Planning Application No. A/NE-TK/864

Table A: Responses to Departmental Comments

Project 項目名稱:
A/NE-TK/864
Proposed Temporary Holiday Camp with Ancillary Facilities for a Period of 3 Years

STORMWATER DRAINAGE PROPOSAL

Drawing Title 圖紙標題:
Land Filling Plan

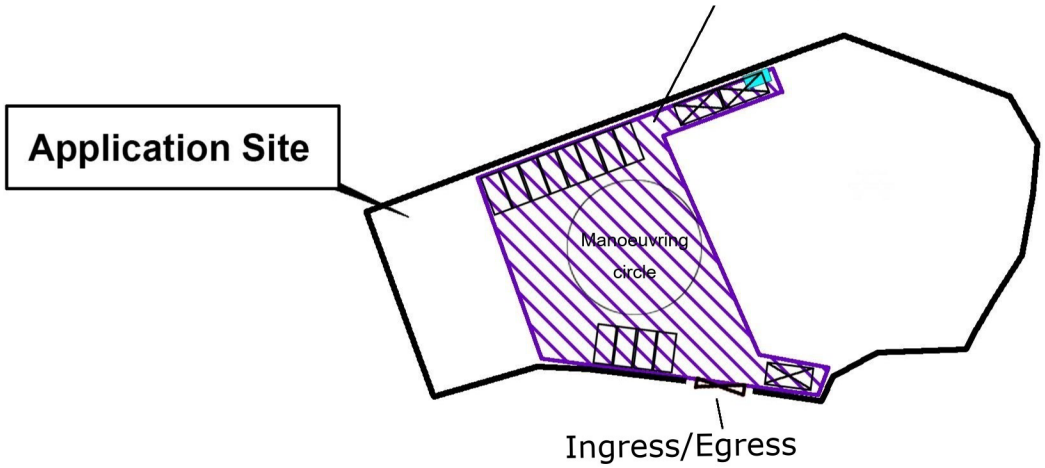
Departmental Comments	Responses
	Planning Department	
1	Please advise whether caravans, cooking activities, usage of open fires and showering facilities will be allowed at the application site.	申請地點內不會停泊任何露營車，擬議發展的營地只專注帳篷露營活動；申請地點內嚴禁任何形式的明火營火，只容許訪客使用便攜式卡式氣體爐具。 申請地點不設沖涼設施。
2	It is noted that there will be overnight camping activities, please advise whether any staff will stay overnight to manage the camping activities and deal with any emergency issues. If affirmative, please review the operation hours accordingly.	為保障過夜留宿訪客的安全並即時處理突發緊急事件，申請人將安排 1 名員工通宵留守於申請地點內。由於有過夜露營活動，本營地的營運時間將修訂為每日 24 小時營業，包括公眾假期。
3	It is noted that there is a transformer at the northwestern tip of the application site, please advise whether it will be retained without being affected by the proposed use.	申請人確認位於申請地點西北角尖端位置的現有電力變壓器（Transformer）將會好好保留，完全不受擬議發展影響。 變壓器周圍將維持足夠的安全距離，並保持通道暢通無阻，以確保電力公司人員能隨時進入進行日常維修或檢查。
4	Please review the extent and area for regularisation of land filling, and revise the plan accordingly.	有關規範化的填土範圍，申請人已修改圖則。 請看附件 1：Revised Land Filling Plan

Land Filling Area
For site formation of structures and circulation path
Area: 830 m² (ABOUT)
Original site level: +9.1mPD (ABOUT)
Existing site level: +9.3mPD (ABOUT)
Depth of land filling : No more than 0.2m
Material of Filling : Concrete

Appendix A — Proposed Stormwater Drainage Layout Plan (Scale 1:500)

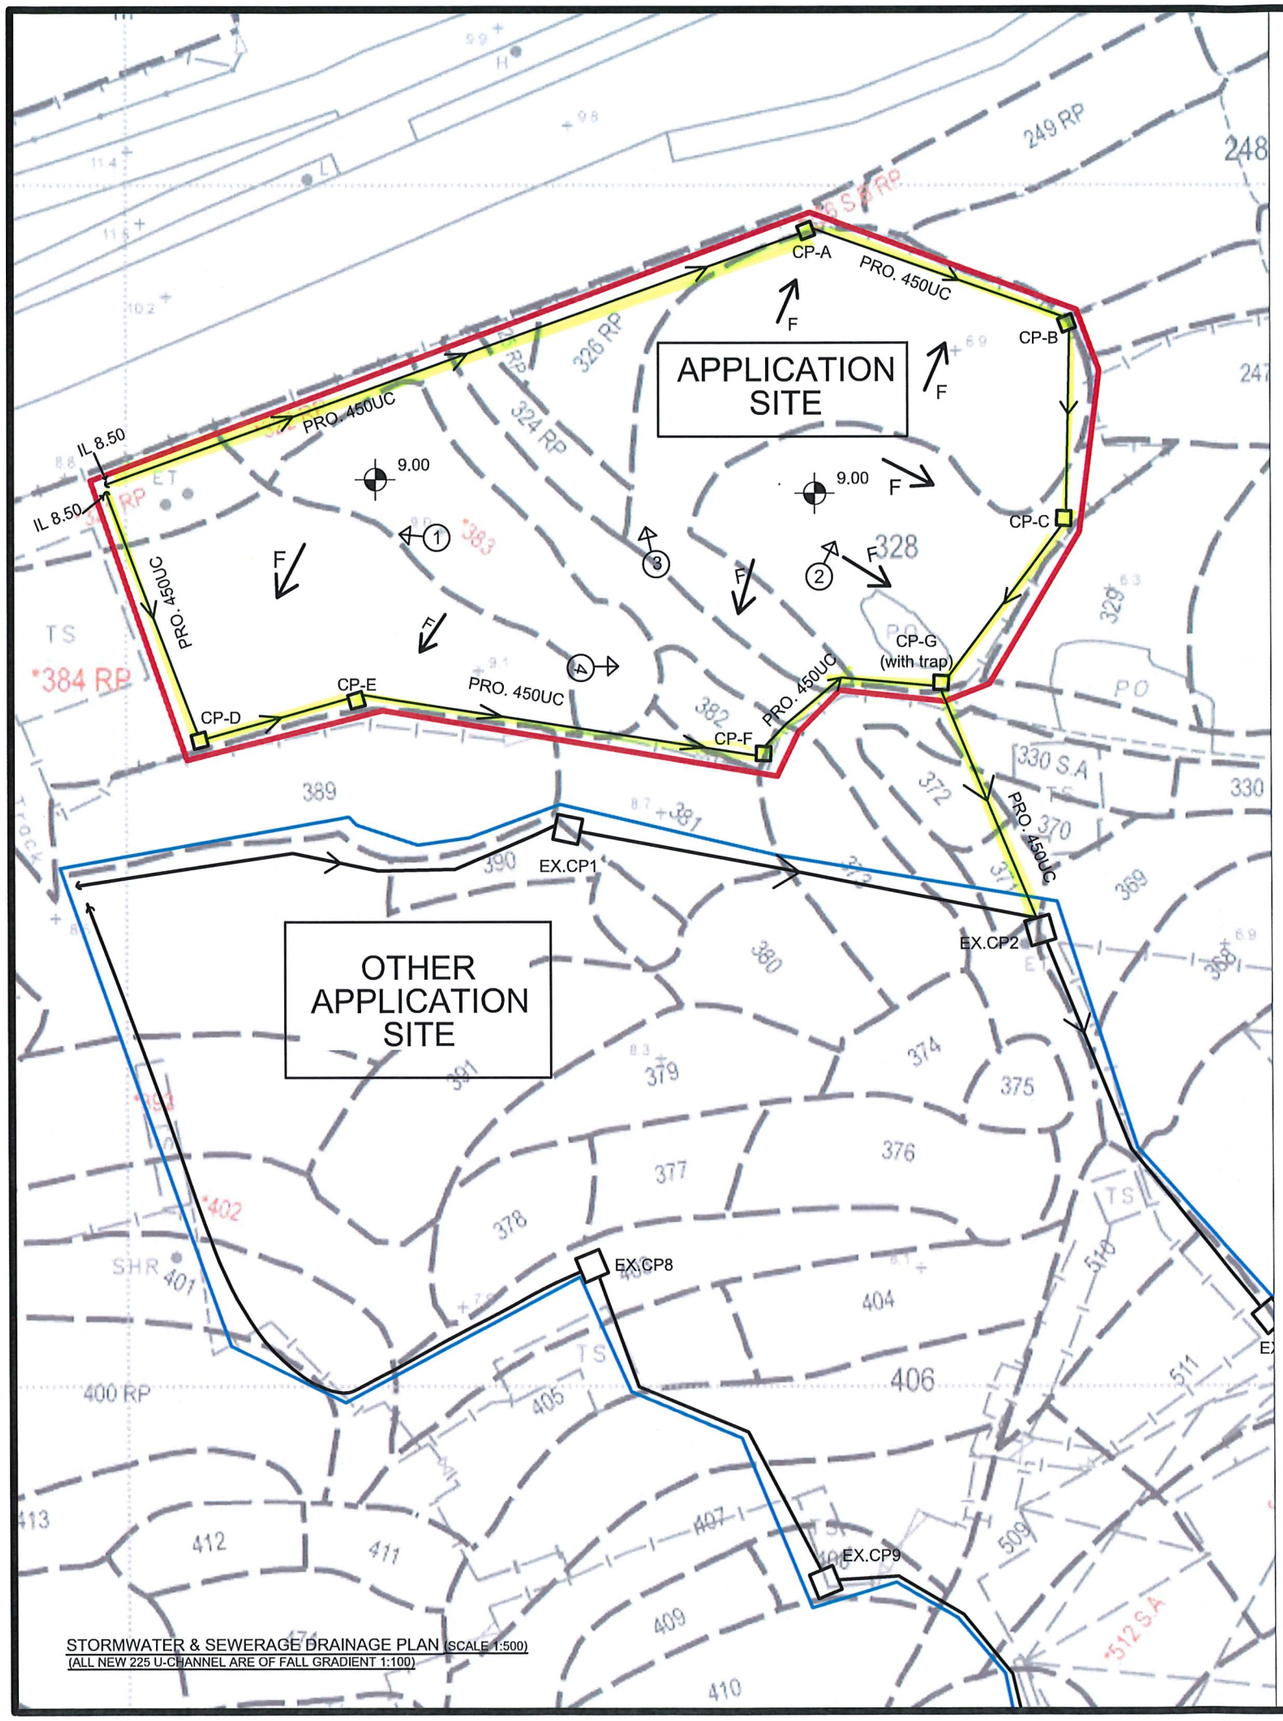
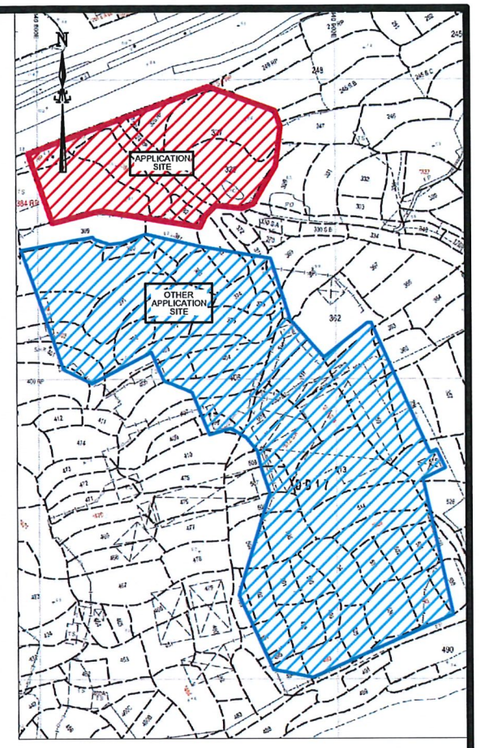
Departmental Comments	Responses
	Drainage Services Department	
	I have reservation on the subject application as there is land filling works to be carried out at the application site which may cause adverse drainage impact to the surrounding lands and premises. As such, the applicant is required to provide further information to demonstrate that the development will not cause adverse drainage impact to the adjacent areas.	申請人已做好排水建議書。 請看附件 2。

A 450mm precast concrete U-channel shall be constructed along the perimeter of the Application Site to intercept and convey surface runoff generated within the site to the designated discharge point.

A catchpit incorporating a sand trap (designated CP-G on the layout plan) is proposed at the final discharge point of the Application Site, immediately upstream of the connection to the existing downstream drainage system. This provision is intended to prevent the discharge of sand or waste into the receiving watercourse and ultimately into the marine environment.

All stormwater collected within the Application Site via the proposed U-channel and catchpits shall be conveyed by gravity flow to Catchpit CP-G. From CP-G, the collected flow shall be discharged into Catchpit CP2 situated within an adjoining application site held under the same ownership.
